Palisades-Goshen Transmission Line Reconstruction Project

**Revision Sheet for the Environmental Assessment
Finding of No Significant Impact
Mitigation Action Plan**

DOE/EA-1591
Bonneville Power Administration

Revision Sheet
for the
Palisades-Goshen Transmission Line Reconstruction Project
Final Environmental Assessment
DOE/EA -1591

Figure 2-2. Existing wood structures and proposed replacement wood structures for the Palisades-Goshen Transmission Line (to be used at all locations except structures 1/2 to 2/7 and 4/1 to 4/8).

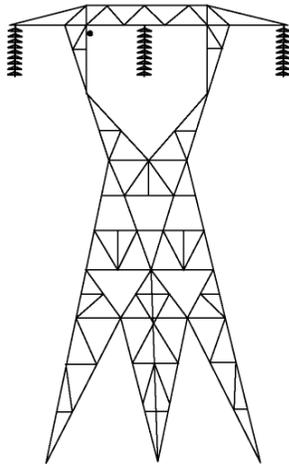
Page 8, the title of Figure 2-2 is modified as follows:
